ADDENDUM

JLG 24146.01-5 Dunn County Public Safety Center

Issued: November 7, 2025

ADDENDUM #: 02

1
E201
Lighting Plan - Level 1
1/8" = 1'-0"

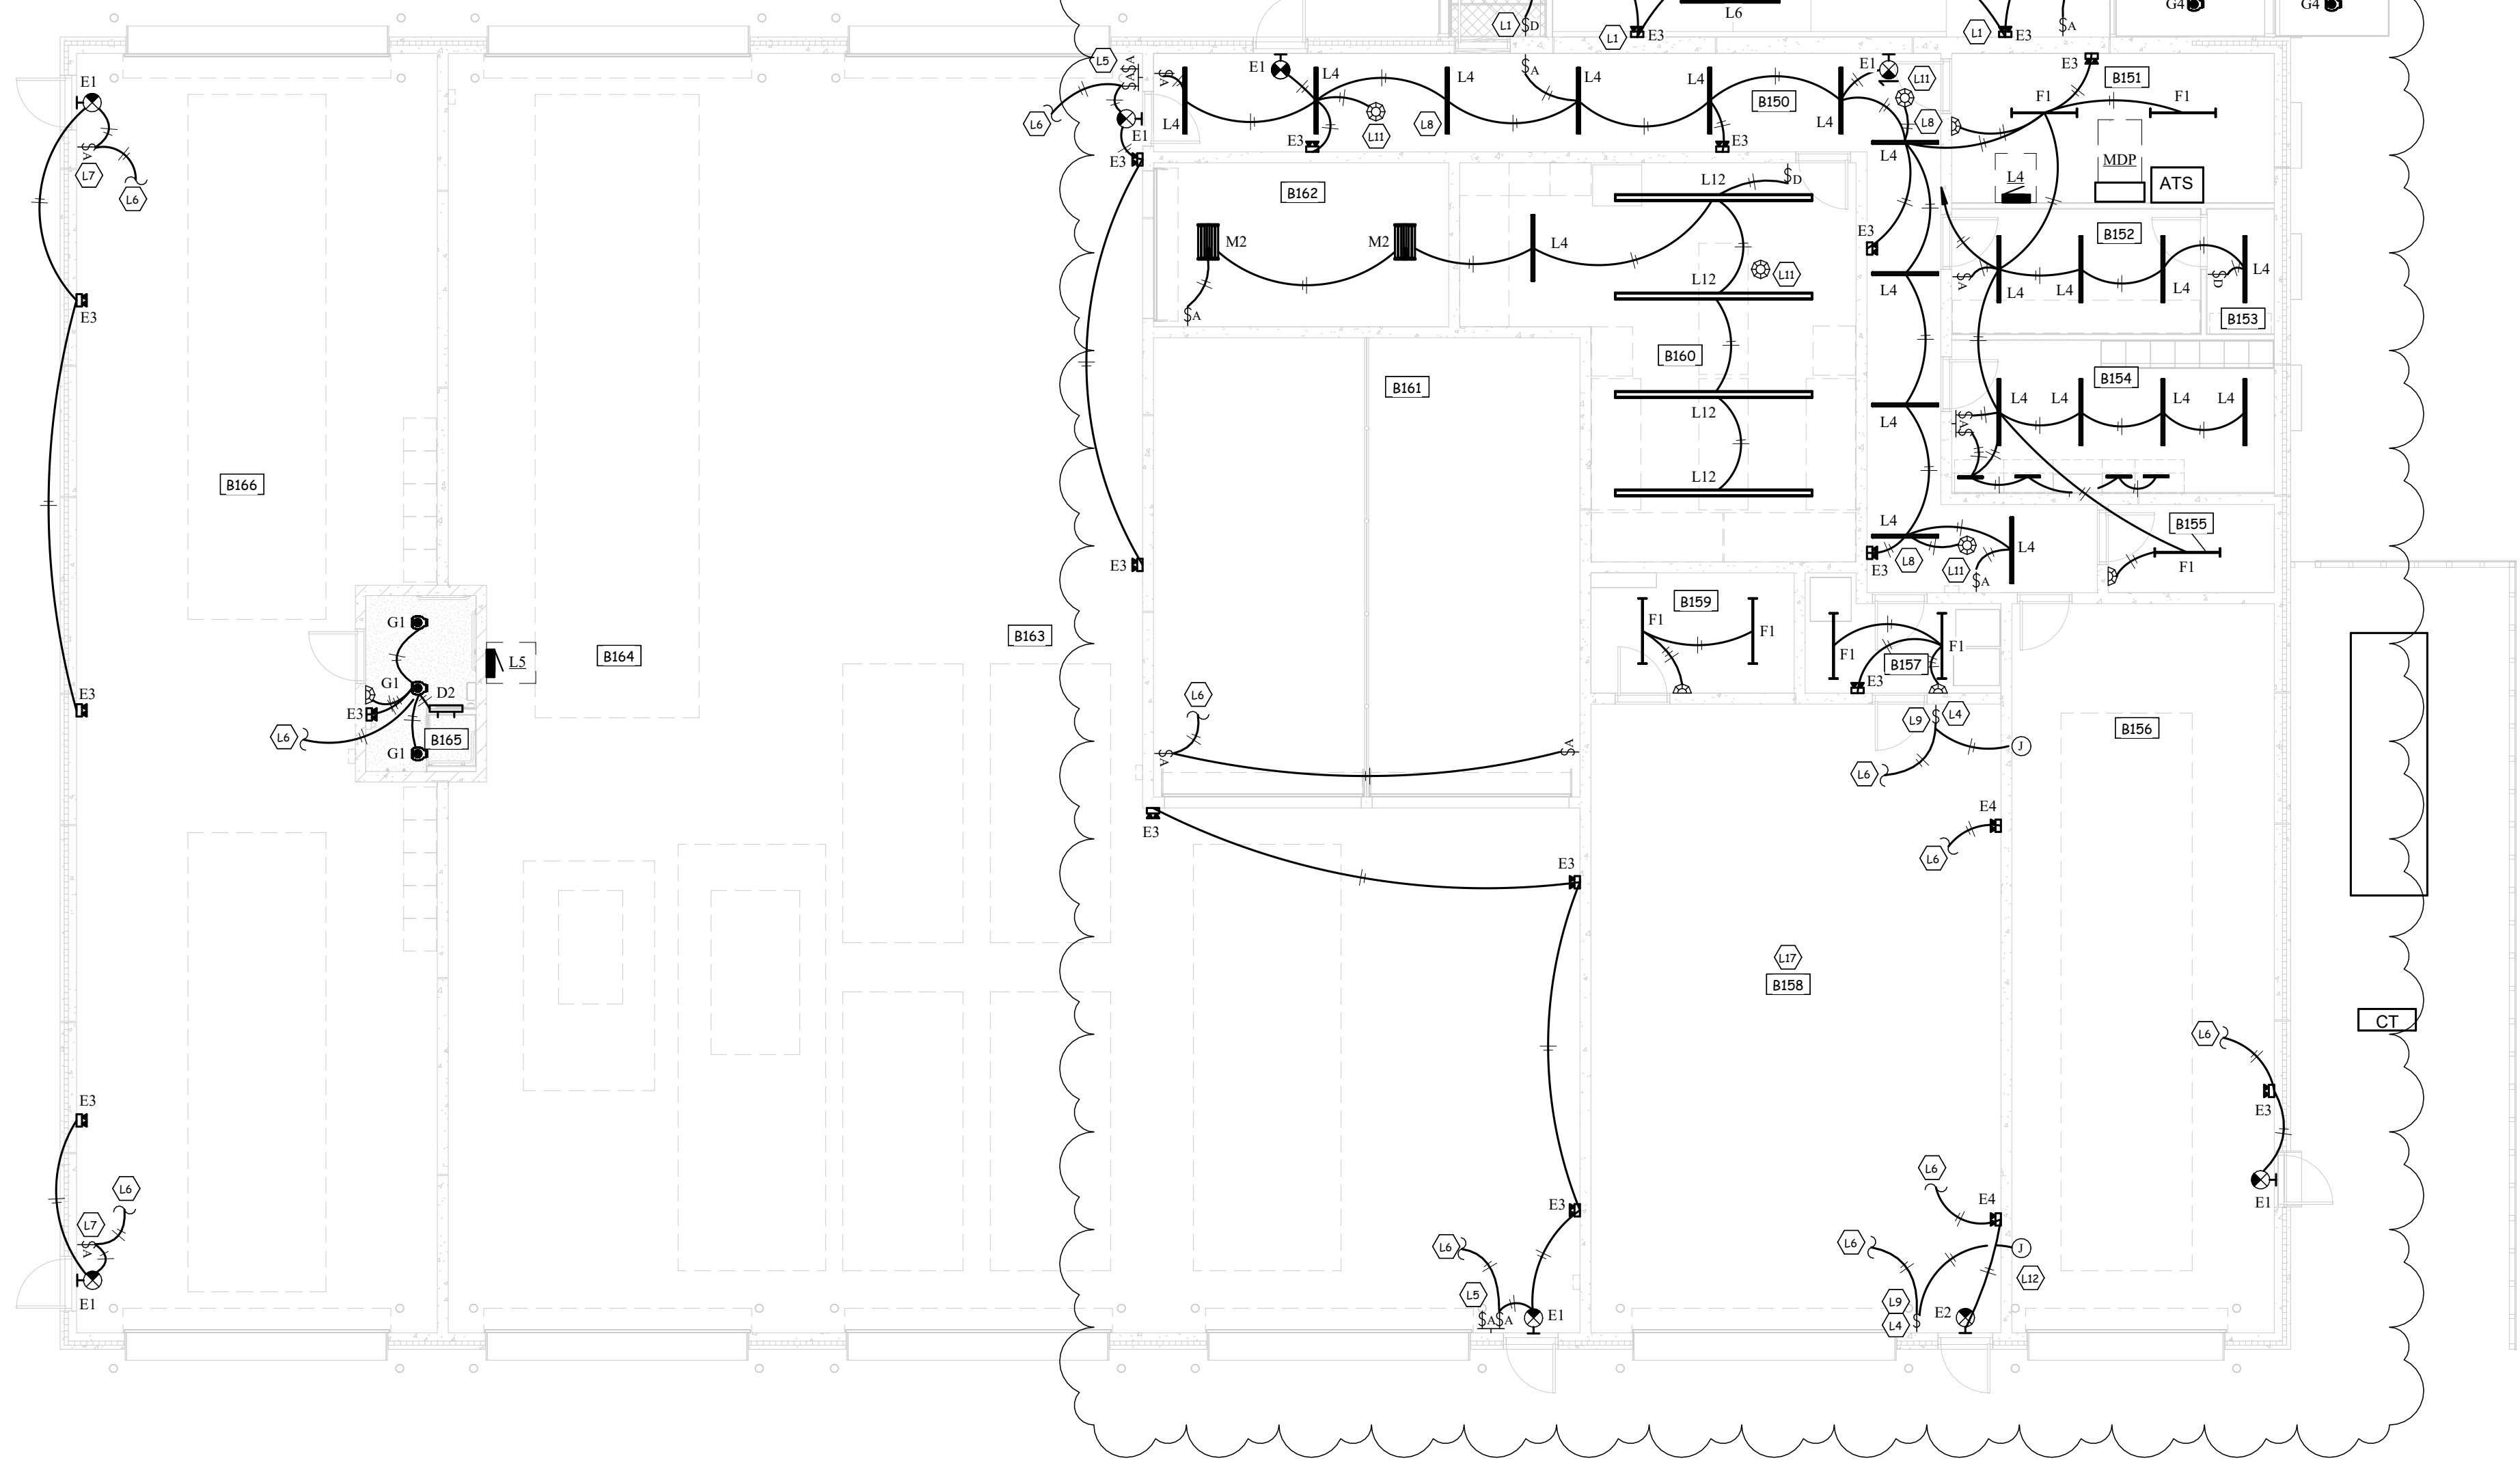
1. E100 – SITE PLAN
 - o Drawing 1/E100: Added Type DD1 fixtures, and added keynotes.
2. E201 – LEVEL 1 LIGHTING PLAN
 - o Drawing 1/E201: Added additional Type U1 fixtures, lighting control locations, and added keynotes.
3. E203 – LIGHTING DETAIL
 - o Detail 3/E203: Updated for flagpole light fixture use.
4. E300 – BASEMENT POWER PLAN
 - o Drawing 1/E300: Updated equipment DP-1 and DP-2 to include disconnects and match mechanical. Added HUH-1, 2, 3, and SP-4.
5. E301 – LEVEL 1 POWER PLAN
 - o Drawing 1/E301: Updated Room A114 water control to be by solenoid rather than electric flush valve and updated keynote.
6. E302 – LEVEL 2 POWER PLAN
 - o Drawing 1/E302: Revised P-8 to be P-6 to match mechanical.

1
E402
Systems Plan - Level 2
1/8" = 1'-0"

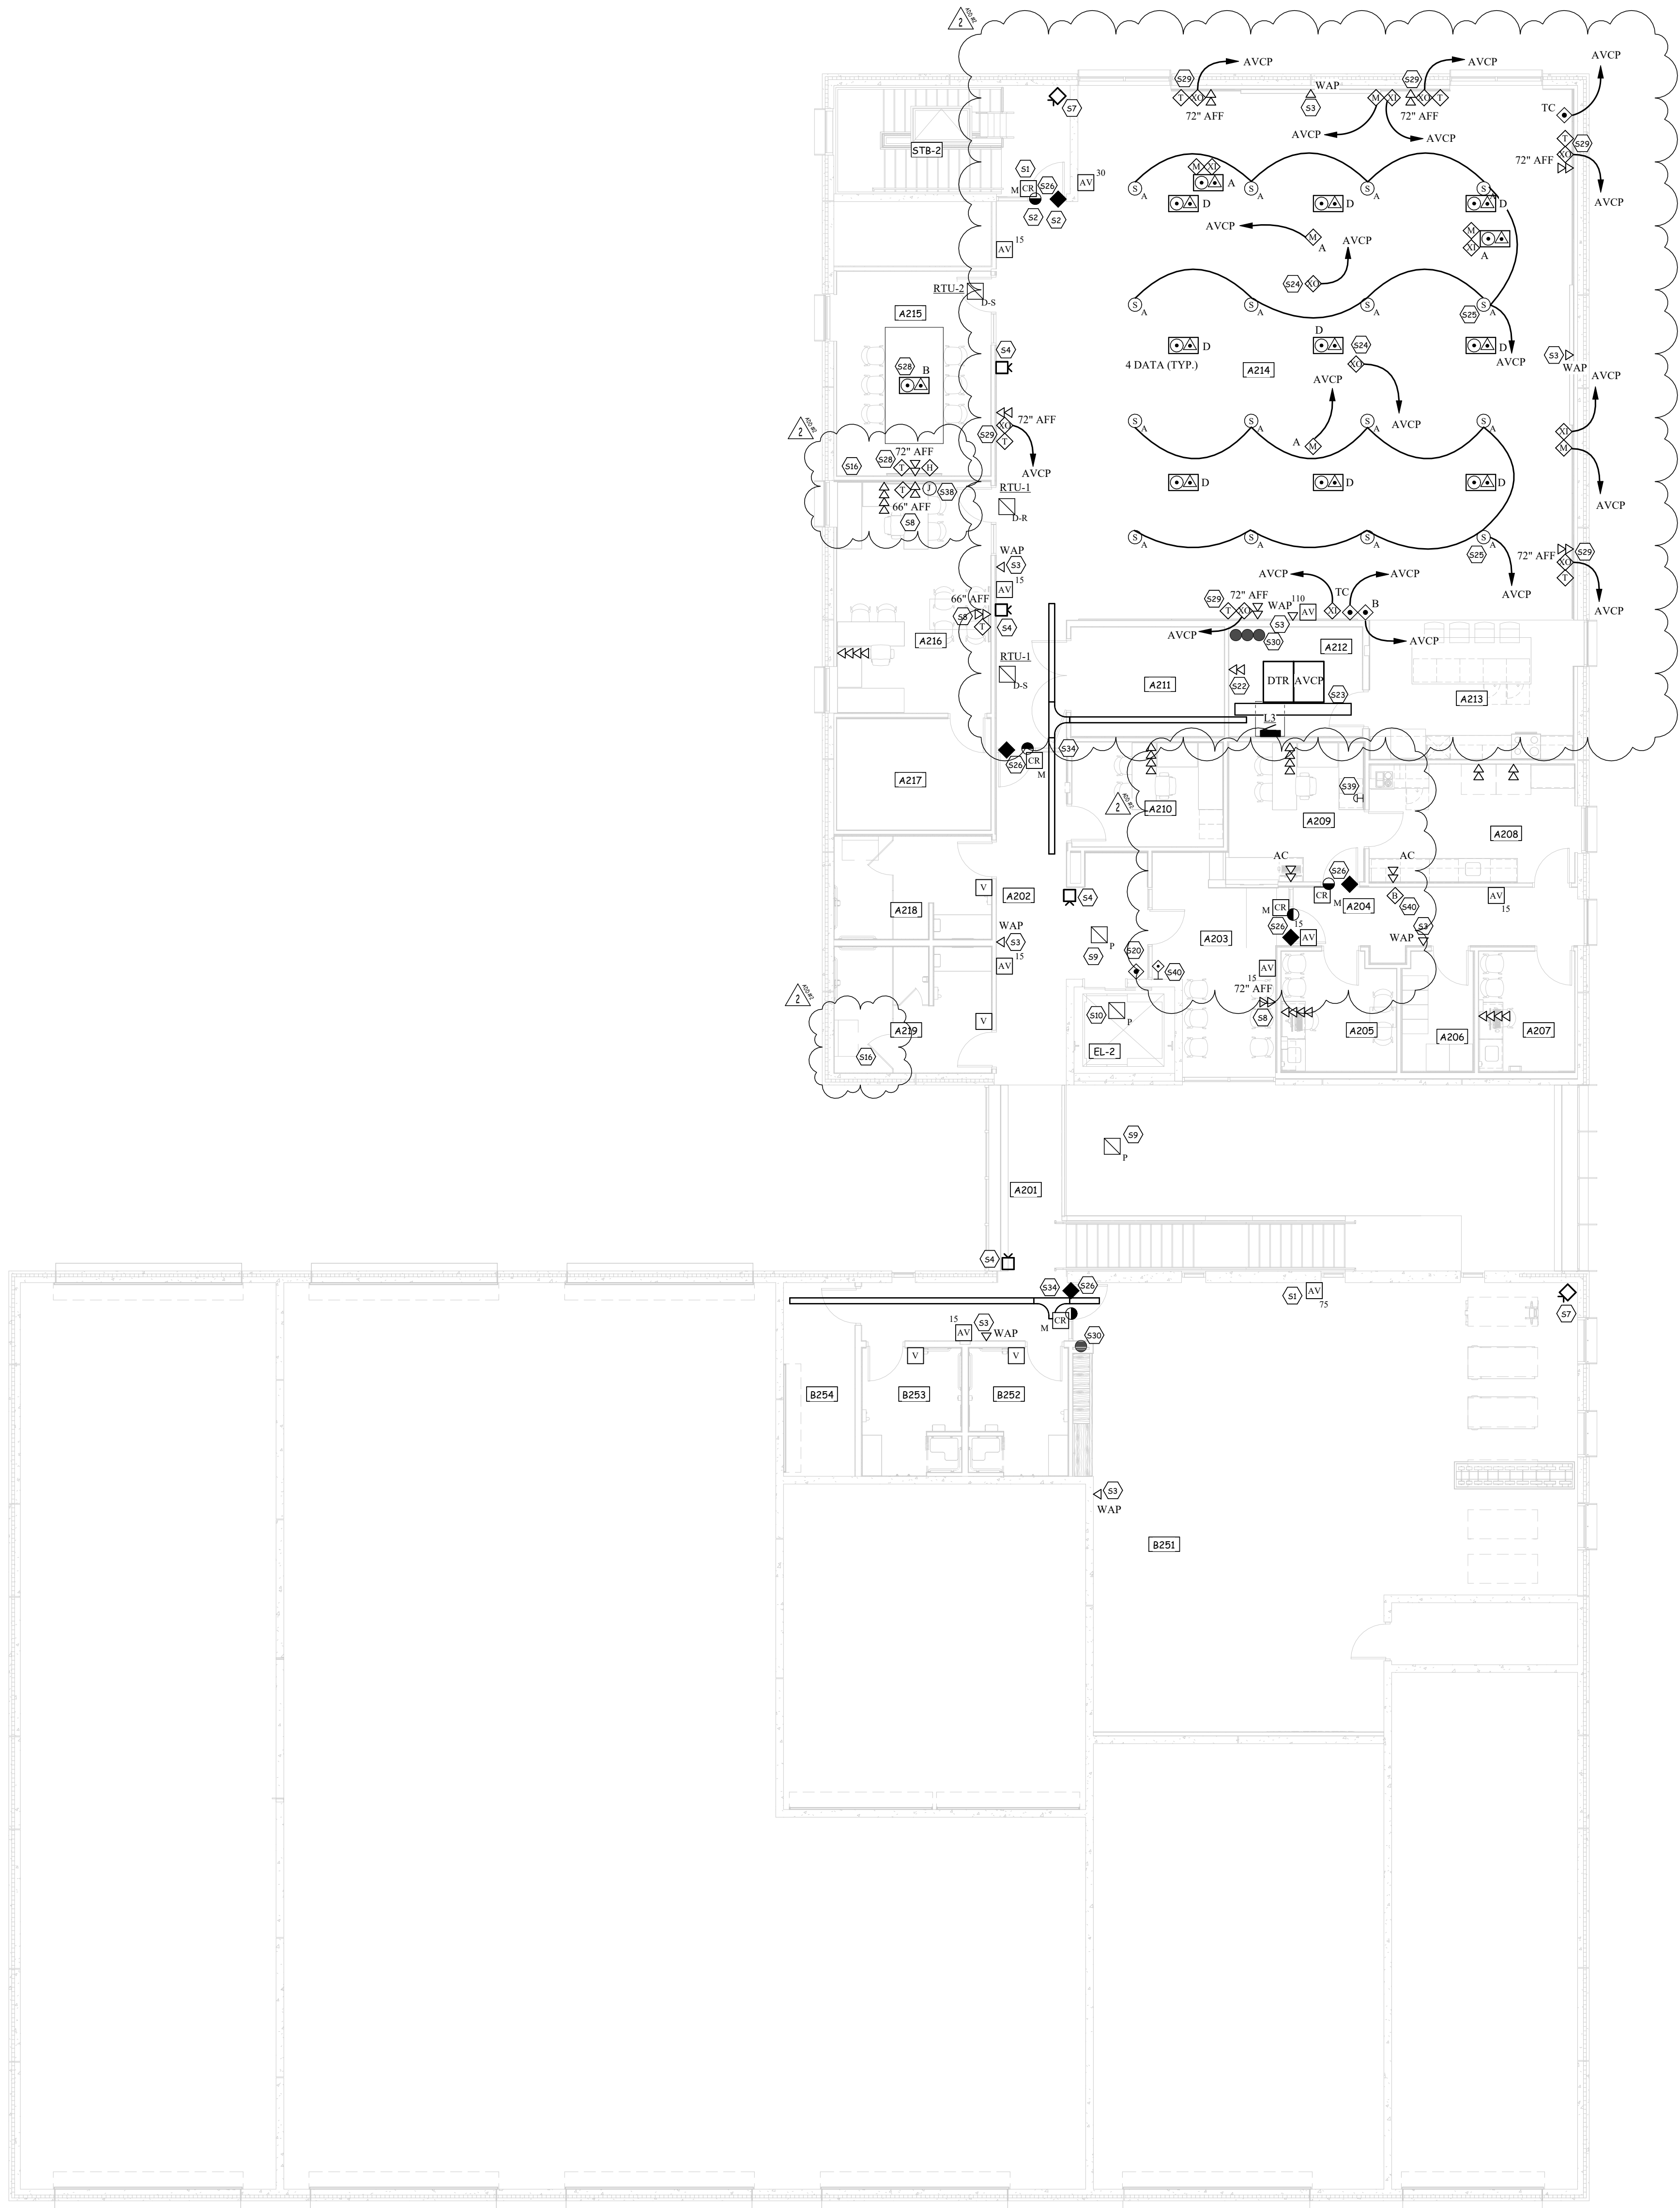
7. E303 – POWER RISER AND PANEL SCHEDULES
 - Panel Schedules: Updated Panel L1 for the added sump pump (SP-4)
8. E304 – POWER DETAILS
 - Motor & Equipment Schedule: Updated for the added sump pump and unit heater. Revised equipment names to match mechanical.
9. E401 – LEVEL 1 SYSTEMS PLAN
 - Drawing 1/E401: Updated various keynotes regarding the radio equipment and system. Added speaker system in the shop and sheriff department hallway.
10. E402 – LEVEL 2 SYSTEMS PLAN
 - Drawing 1/E402: Updated keynotes regarding the radio equipment and system. Added antenna location. Antennas must be 50 ft apart and have continuous conduit from service mast to base station(s).
 - Drawing 1/E402: Updated device heights, added panic button rough-in, and added doorbell system.
 - Drawing 1/E402: Updated various items for the training room multimedia system.
